STAFF RECOMMENDATION 2310 Belmont Boulevard August 15, 2018

Application: New Construction—Addition and Outbuilding (Detached Accessory Dwelling Unit); Partial Demolition

Applicant: Martin Wieck, Nine 12 Architects

Description of Project: The applicant proposes construction of a rear addition and detached accessory dwelling unit. The plan includes demolishing an existing rear addition and converting an existing door on the front façade to a window.

Figures 2 and 3: Addition to be demolished (left) and 1951 Sanborn map footprint (right)

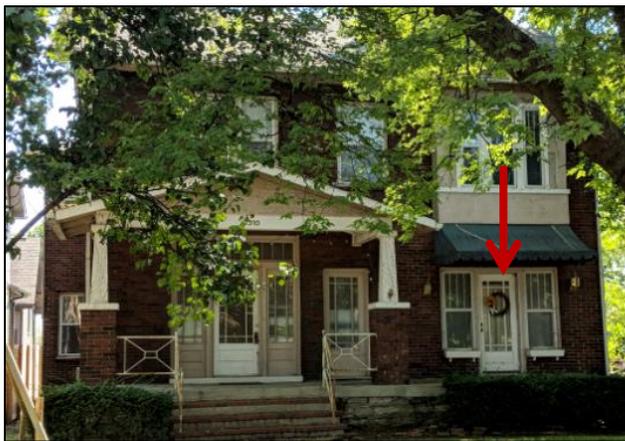
Partial Demolition: The application includes demolishing an existing rear addition and converting an existing door on the front façade to a window. The addition to be demolished is located at the rear of the existing house and sets in four feet (4') from the

right corner (Figure 2). The addition was constructed after 1957 as it does not appear on the 1957 Sanborn map (Figure 3). Staff finds the removal of the rear addition to be appropriate given its location at the rear. Staff finds that the proposed partial demolition meets Section V.2 for appropriate demolition and does not meet Section V.1 for inappropriate demolition.

FLOOR PLANS

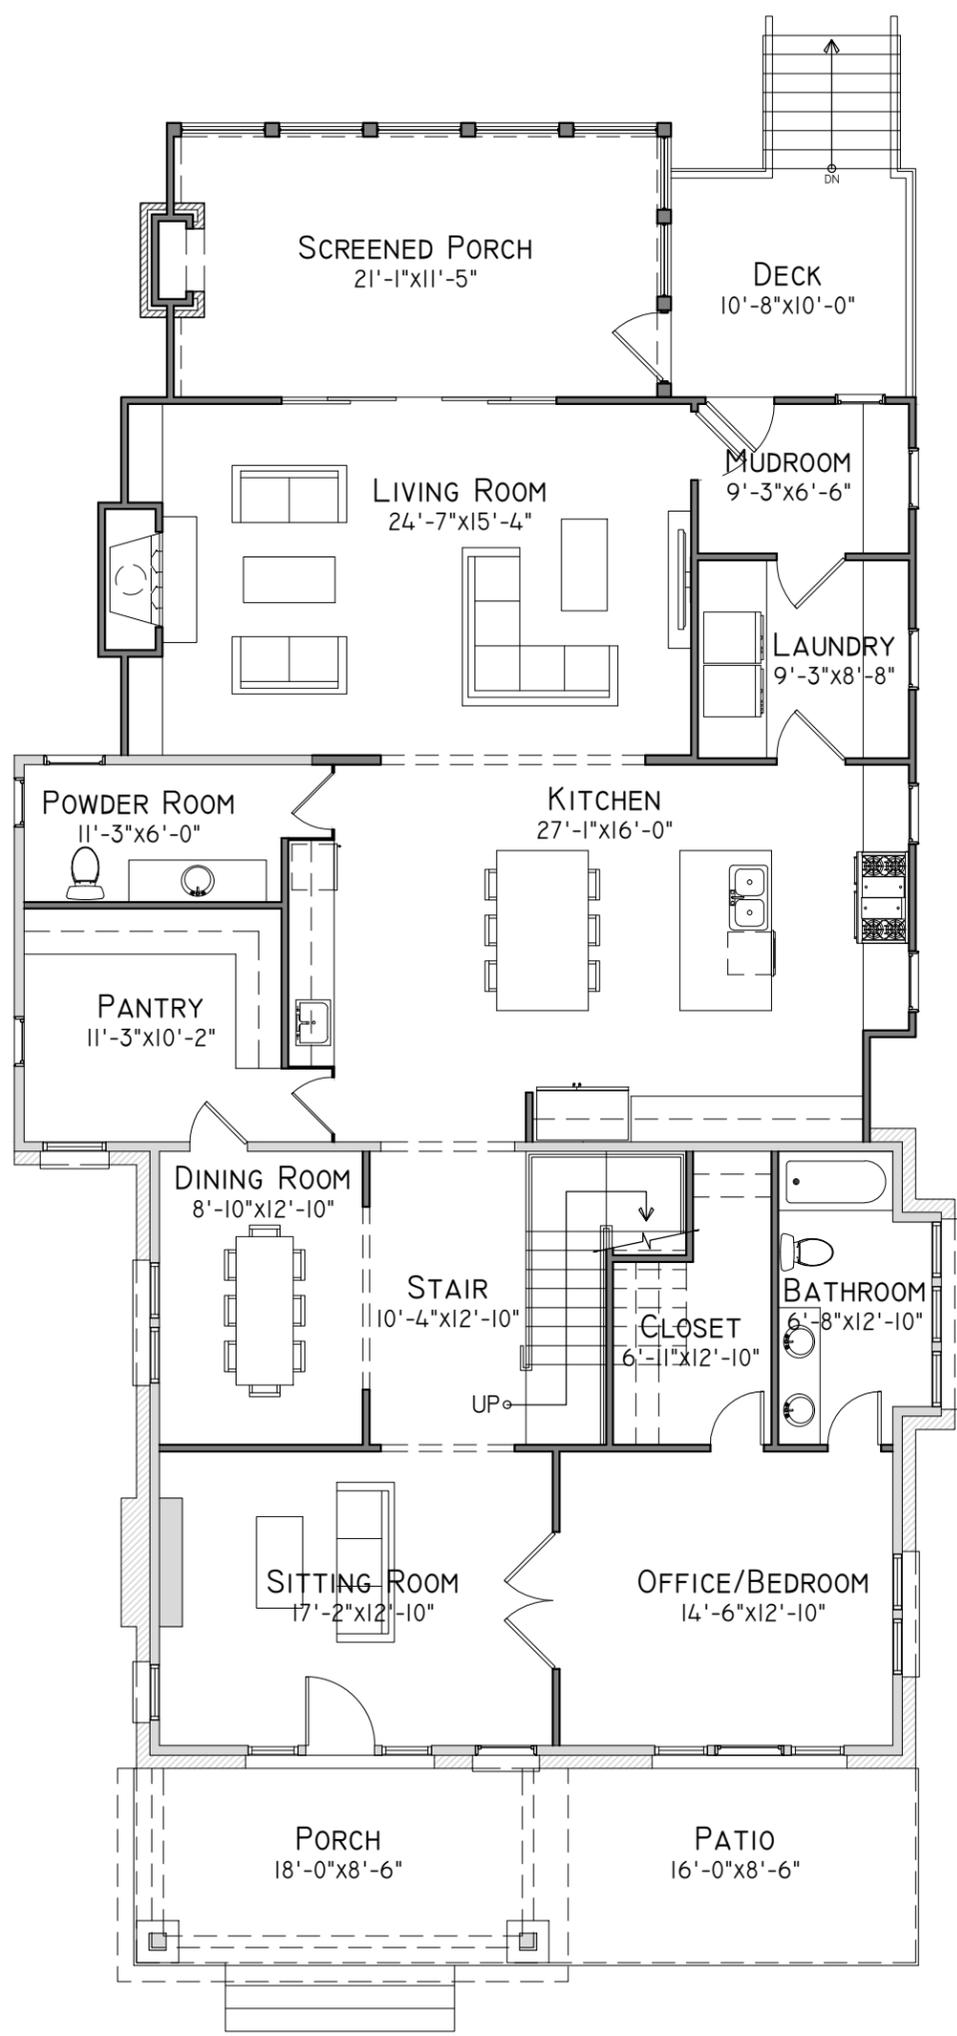
The proposed outbuilding is seven hundred seventy-five square feet (775 sq. ft.), which exceeds the maximum allowance of seven hundred fifty square feet (750 sq. ft.). The footprint is labeled as seven hundred forty-five square feet (745 sq. ft.) on the site plan, but staff calculated the footprint to be higher when measuring from exterior wall to exterior wall and including the projecting bay window on the rear façade. Second-level projections are included in the footprint since they increase the massing of the proposal and create covered space on the ground level. Small upper-level decks have been approved but only when they are not covered or enclosed. Although the bay is minimal, it could set a precedent for future projecting and cantilevered upper levels which would undermine the overall maximum massing that the guidelines are attempting to control. Staff recommends that the footprint of the proposed DADU be reduced to a maximum of seven hundred fifty square feet (750 sq. ft.).

The proposed outbuilding is twenty-seven feet (27') feet tall, which exceeds the guidelines for height. Staff recommends reducing the overall height so that it does not exceed the maximum of twenty-five feet (25') tall. The two-story DADU will have an eave height of seventeen feet (17'). The eave height meets the design guidelines and is appropriate since the historic house is two stories.

With the conditions that the footprint be a maximum of seven hundred and fifty square feet (750 sq. ft.) and the overall height be a maximum of twenty-five feet (25'), staff finds that the project can meet Section II.B.i.1 of the design guidelines.
